# **Reviewer Report for the S2 Time-Domain Pulsar Search**

**LSC Meeting  
June 5, 2004**

# Checks of Results

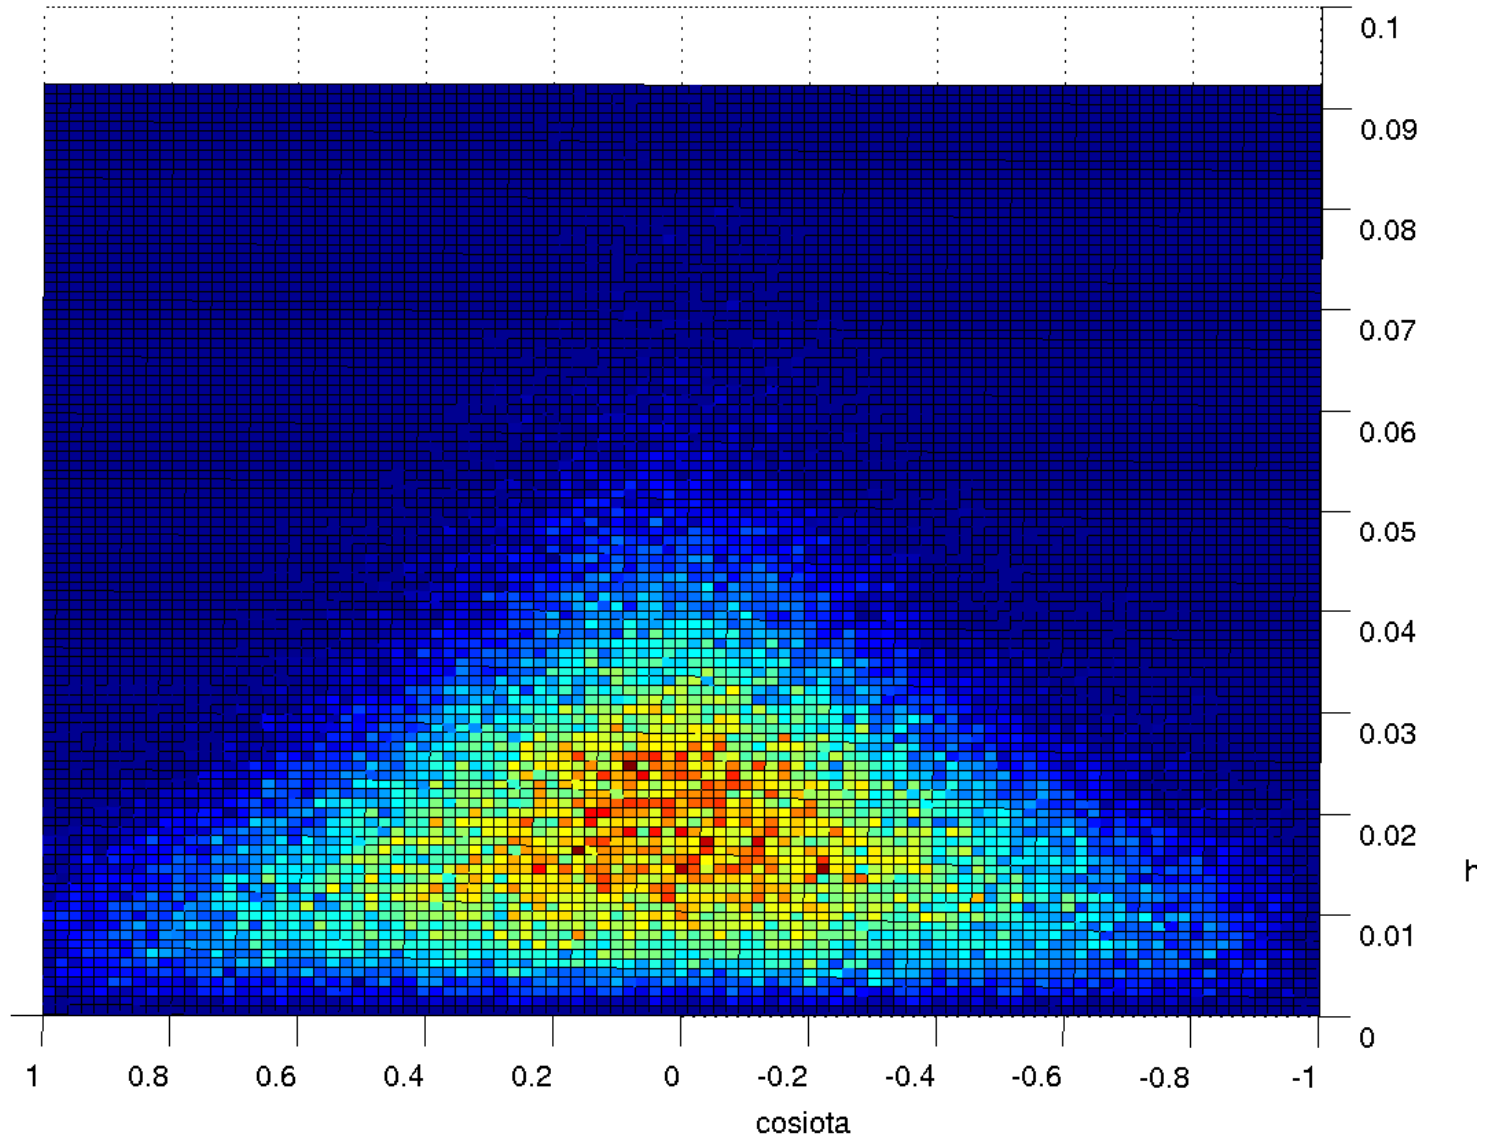
## Examined posterior pdf distributions and numerical limits

Sanity checks

Consistency check

# Checked calculated upper limits against expectations

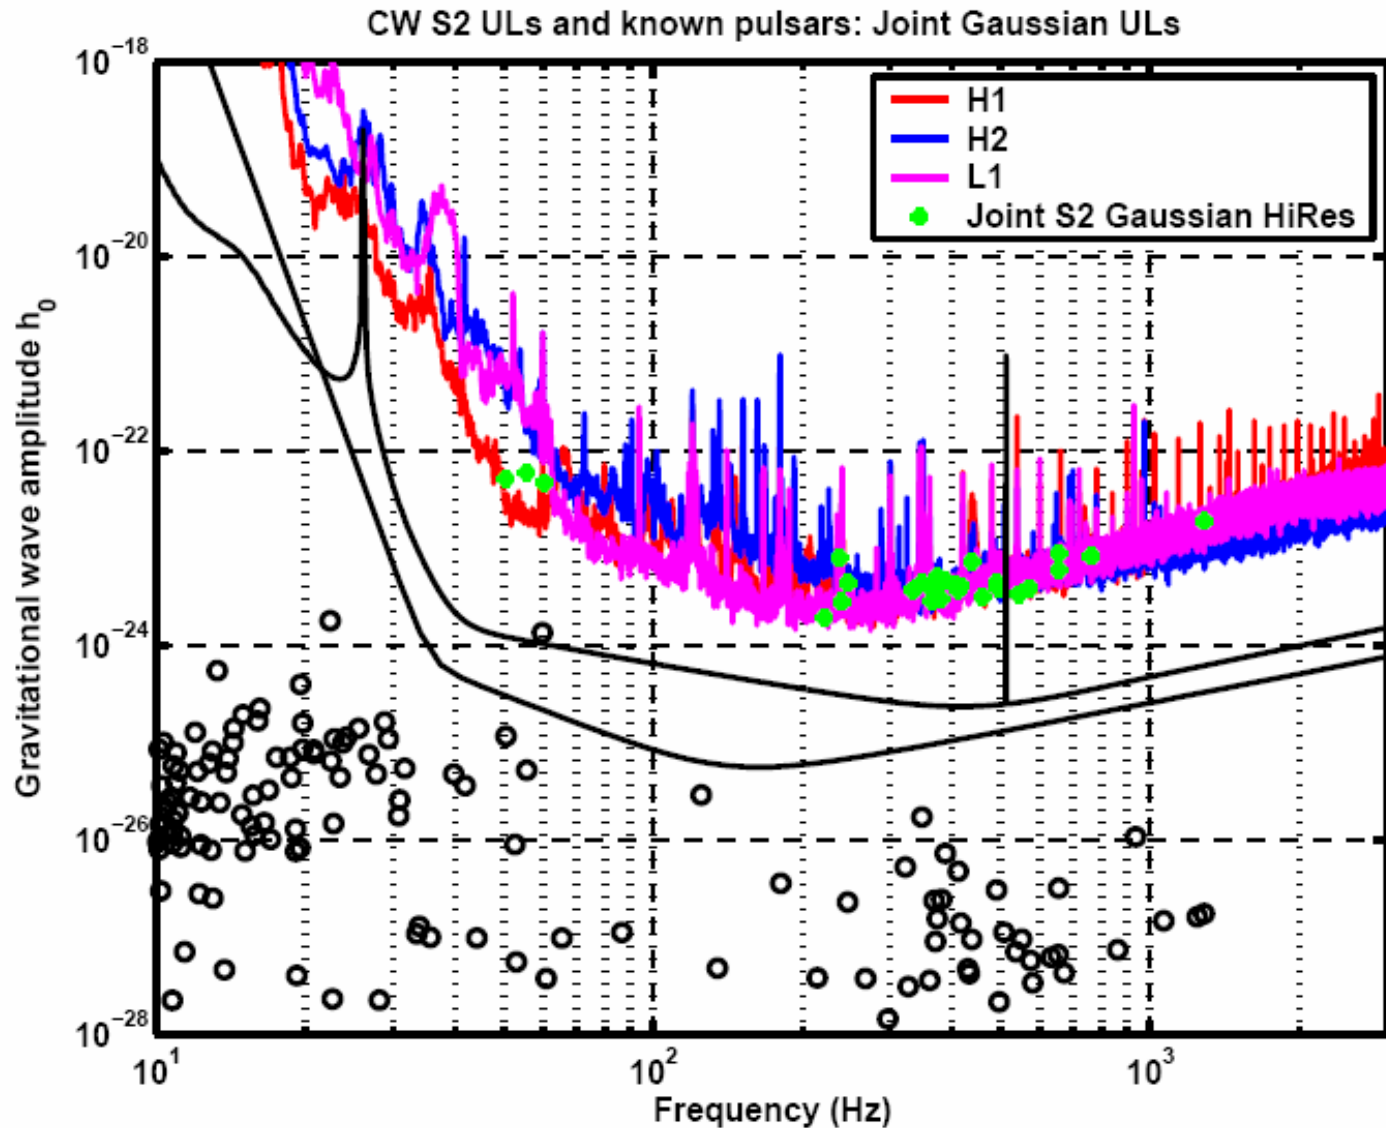
Given noise curves
